SUBJECT: STARTER ASSEMBLY A-00793**AFFECTS:** DM40 AND 410

TECHNICAL SERVICE BULLETIN

NO. 188-003

SUBJECT: TOGGLE SWITCH & PLATE ASSEMBLY

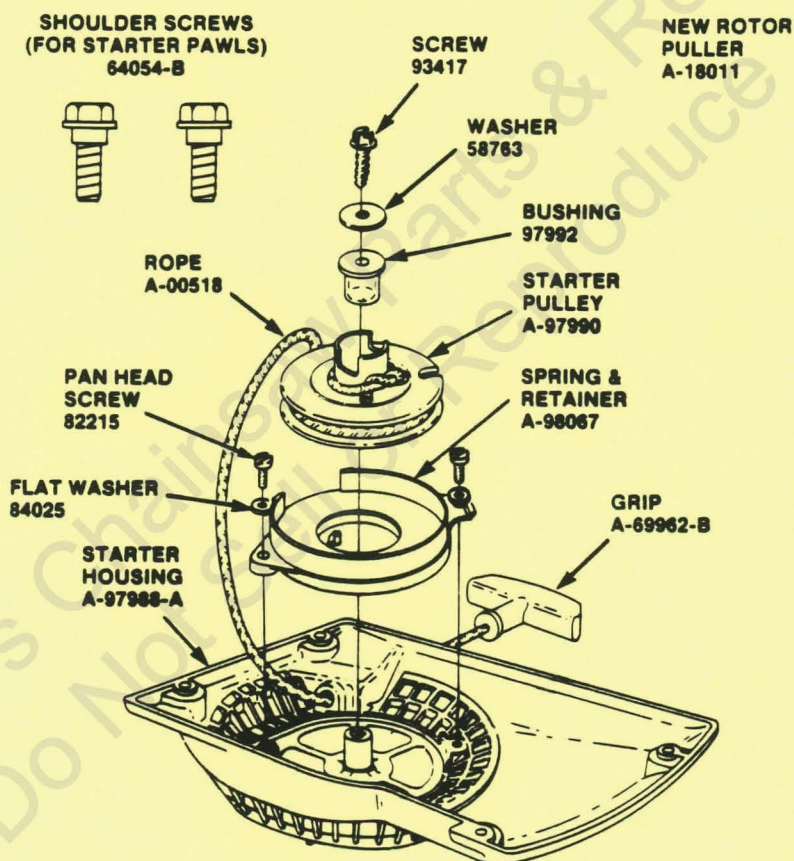
A new revised Starter Assembly is available for the above saws. Below is a breakdown of the new parts and part numbers used in this assembly.

Both the spring and retainer (P/N A-98067) have been improved. The hole in the center of the retainer is smaller which retains the spring when fully wound. The hook on the spring has been reformed to match the diameter of the hub.

It is important that you use the new pulley (P/N A-97990) with the A-98067 Spring and Retainer. The new pulley has been modified to retain the spring hook better than the old pulley (See Technical Bulletin 186-017). The rope is double wrapped around the hub with a metal ferrule installed on the end. This will prevent the rope from pulling out of the starter. New shoulder screws (P/N 64058-B) MUST be installed with this starter assembly. The new shoulder screws do not have the threaded studs. If shoulder screws with threaded studs are used the studs will catch on the starter rope and damage the starter assembly. A new rotor puller (P/N A-18011) is available for units using the new shoulder screw.

SUBJECT: THREE-SHOE UNLINED CLUTCH A-79237**AFFECTS:** 330 (STARTING WITH S/N HI2450826)

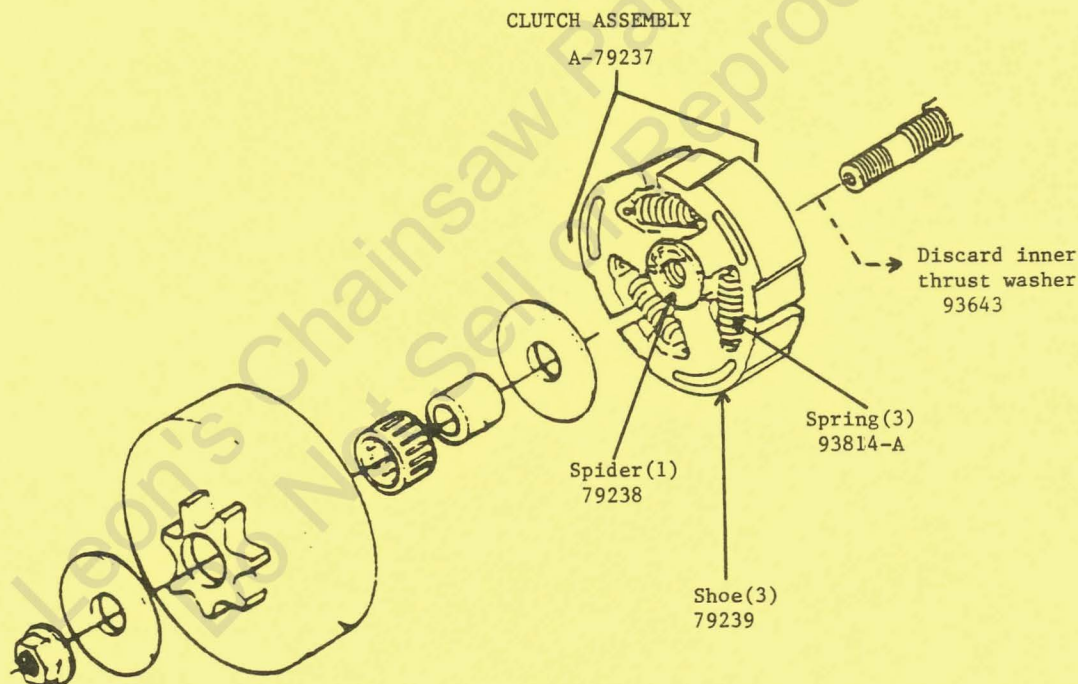
A three-shoe unlined clutch assembly A-79237 has replaced the three-shoe lined clutch on the Model 330 chain saw. The older spider 94374 will supersede when exhausted to the unlined clutch assembly. Refer to the diagram below when ordering parts for this new clutch assembly.

Discard inner thrust washer 93643 (located between clutch assembly and crankshaft) when installing the new A-79237 clutch assembly.

Install clutch assembly A-79237 with the "OFF→" facing out. Torque clutch assembly to 250 - 300 in.lbs. (28,2-33,9 Nm).

Installing a clutch assembly backwards (with the counter bore facing out) could result in breakage of the crankshaft.

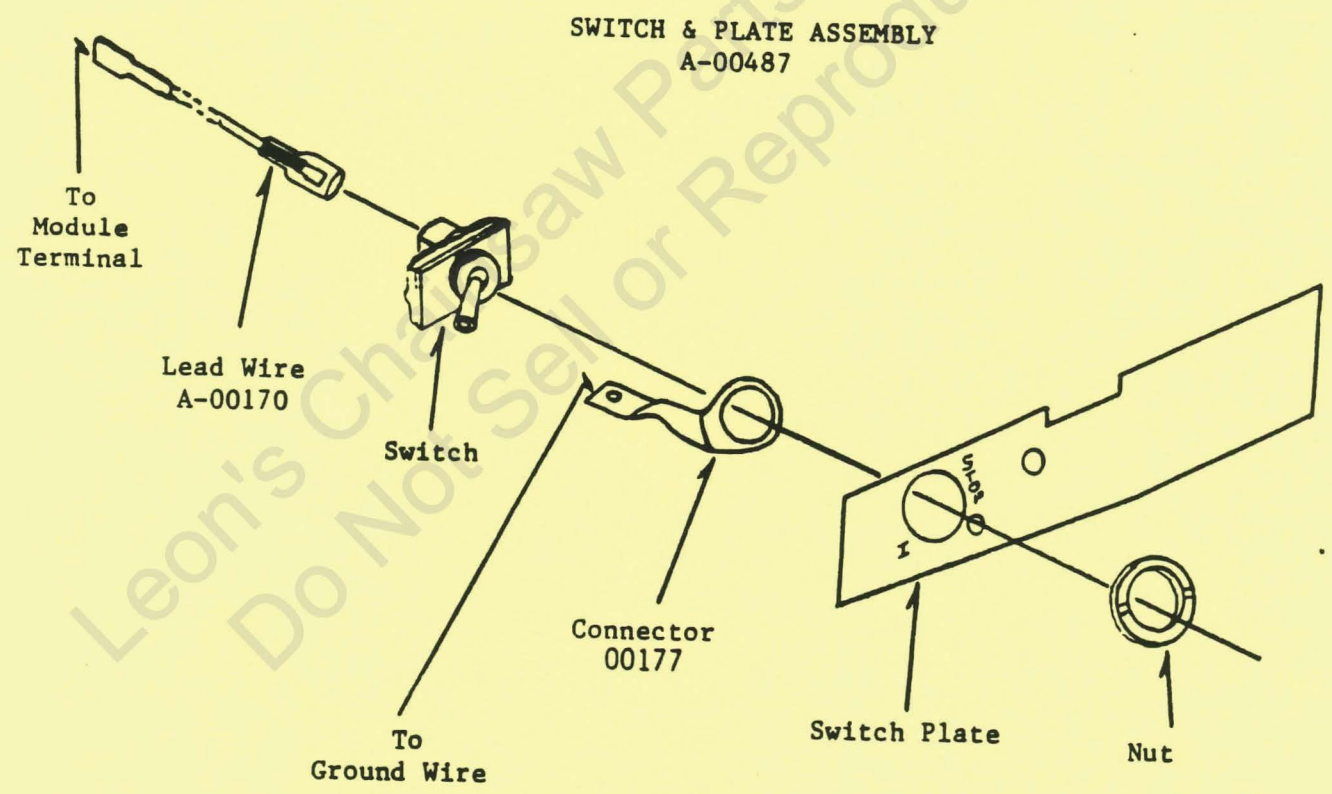
The plastic on-off switch 98377 used on the subject model chain saws has been superseded by a new toggle switch and plate assembly A-00487. This assembly is supplied with a new module lead wire A-00170 and ground connector 00177 in order to retrofit older units.

Refer to the diagram below when assembling or ordering parts for the new switch assembly.

SUBJECT: REPLACEMENT SPROCKET NOSE ASSEMBLIES FOR SP SERIES GUIDE BARS**AFFECTS:** CHAIN SAWS

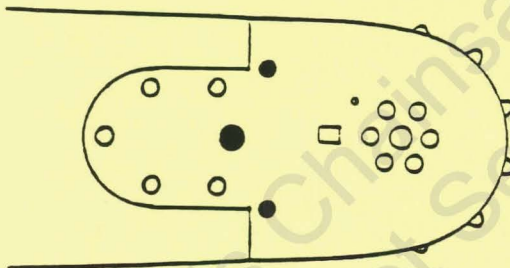
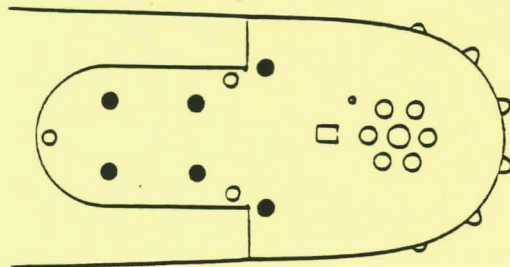
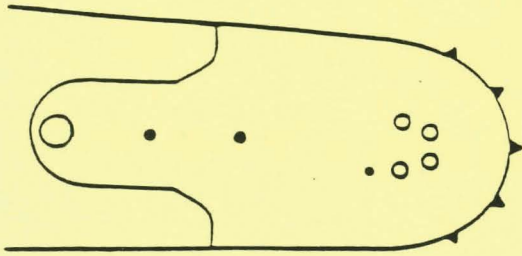
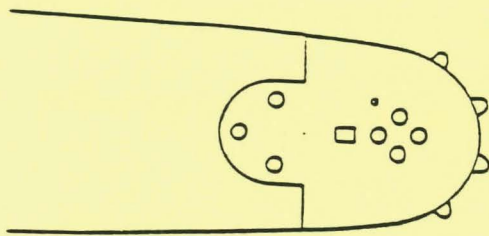
A five rivet sprocket nose assembly is now being used on SP series (H5, H2) Windsor style guide bars. The older three rivet nose assembly will not interchange with the five rivet design.

FIVE RIVET NOSE ASSEMBLY used on
H2 and H5
Windsor style SP series guide bars

THREE RIVET NOSE ASSEMBLY used on
A2 thru G2 and A5 thru G5
Windsor style SP series guide bars

ONE RIVET NOSE ASSEMBLY used on
H5
Oregon style SP series guide bars

THREE RIVET NOSE ASSEMBLY used on
H6
Windsor style SP series guide bars

SUBJECT: CARBURETOR ADJUSTMENT**AFFECTS:** ST-145, 155, 175, 175C, 185, 285, 385, 485

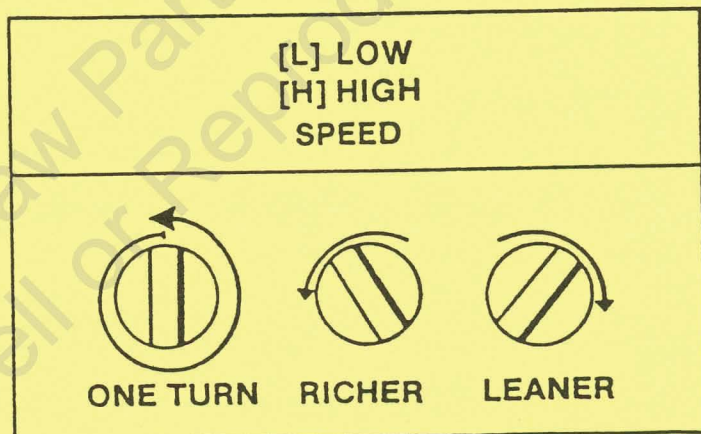
Always be sure the throttle lever is opening fully.

- 1) With the throttle wide open, slowly turn the High speed needle counter-clockwise (rich) until the engine begins to run rough (called four-cycling)
- 2) Slowly turn the High speed needle clockwise (lean) until the engine runs smoothly (a minimum of 6200 RPM).
- 3) With the engine running smoothly, turn the High speed needle counter-clockwise (rich) $\frac{1}{8}$ of a turn. This should prevent a lean running mixture which will seize the piston in the cylinder.

SUBJECT: 1) HDA SERIES WALBRO CARBURETOR
2) HDC SERIES CARBURETOR REPAIR KITS

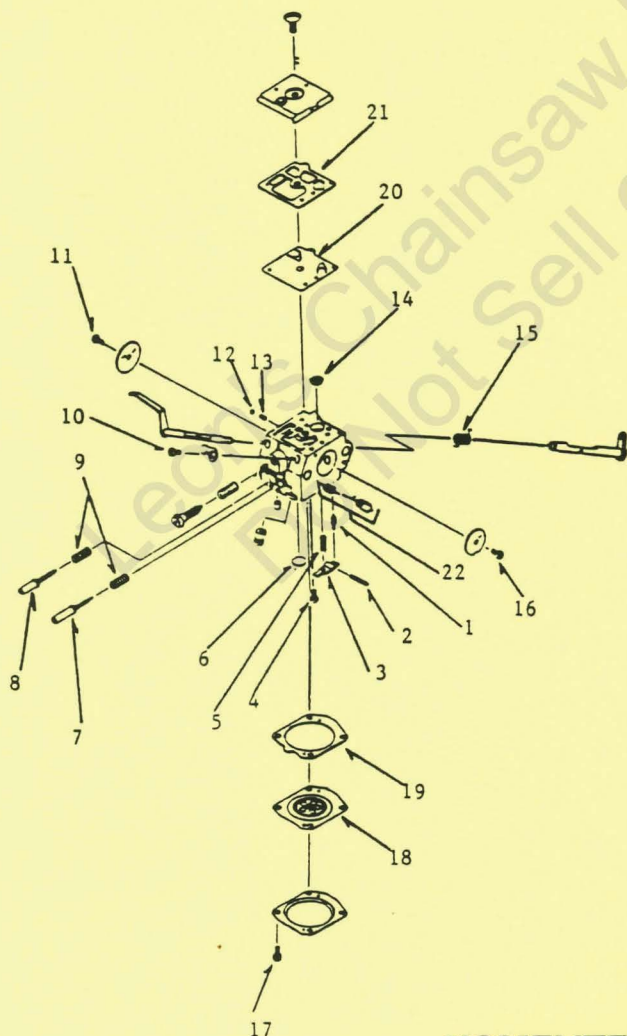
- 1) The Walbro Model HDA series carburetors are now being used on the XL family of chain saws. Improved idling and acceleration characteristics have been achieved with the use of an accelerator pump (see item 22 below) on these new carburetors.

Carburetor A-94649-E (Walbro HDA-60) will be used on the models XL & Super 2 and to service older models XL-2 and 190. Carburetor A-96621-D (Walbro HDA-64) will be used on the VI Super 2 series (production and service). The only difference in the two carburetors is the choke lever.

Repair parts for the older HDC series will not interchange with the new HDA carburetors. Refer to the illustration below when ordering repair parts for the HDA series.

A-01093
PULLEY CONVERSION KIT

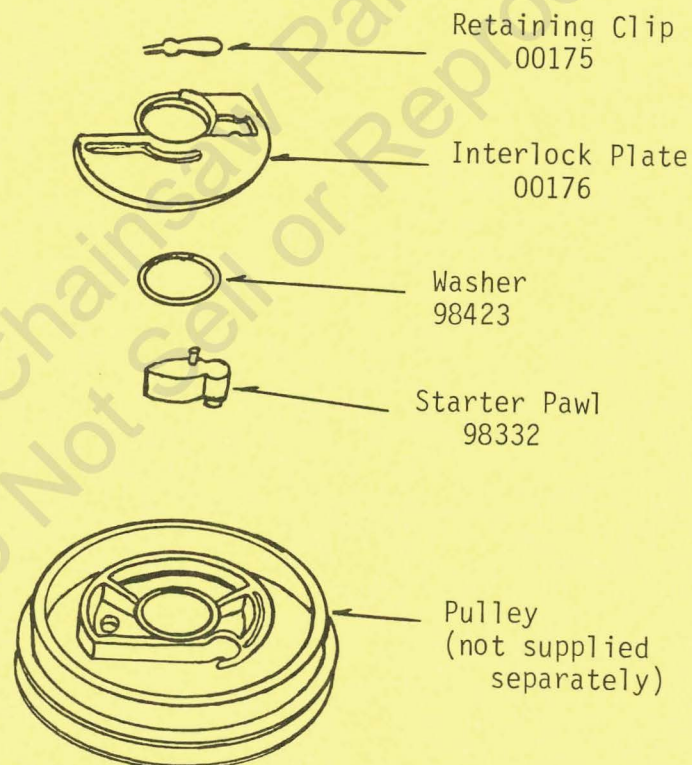
1. The starter pulley on the subject model chain saw has been revised to include an interlock plate (00176) and new retaining clip (00175). The older pulley 98329 will supersede, when exhausted, to a pulley conversion kit A-01093. The parts contained in pulley kit A-01093 are illustrated below.

Page 3, Figure 2

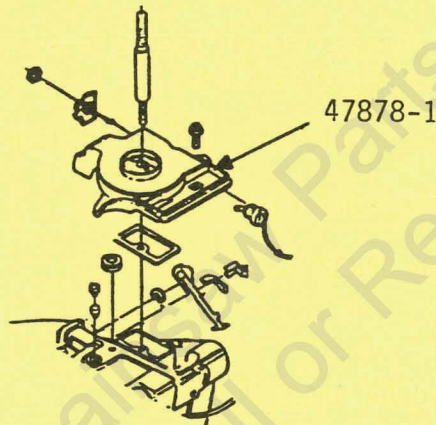
The air filter support part number was never shown. The part number is 47878-1 (see illustration below)

SUBJECT: INCORRECT WIRING AND FUEL LINE ROUTING**AFFECTS:** 176BI40-A (UT-03629-A)

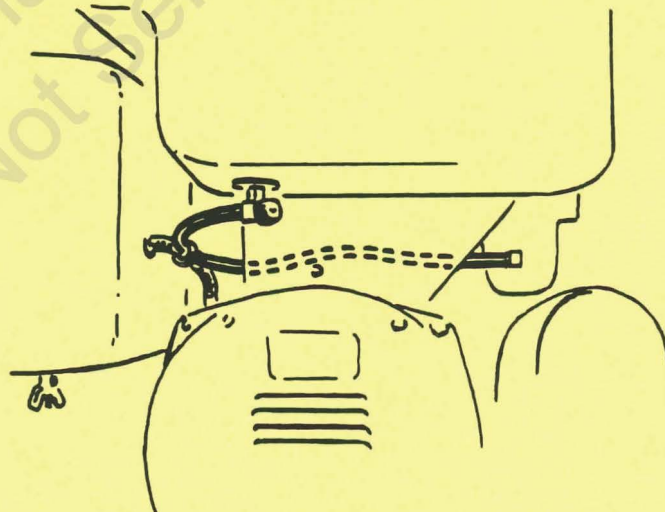
All 176BI40-A Generators with serial numbers HJ2560001 through HJ2560229 should be inspected for the following:

1. On/Off Switch Wiring

2. Brush head terminal. Remove cover and fan to inspect terminal. Terminal should be bent toward generator not toward fan.
3. Fuel line should be held in place by the tie at the back of the control panel.
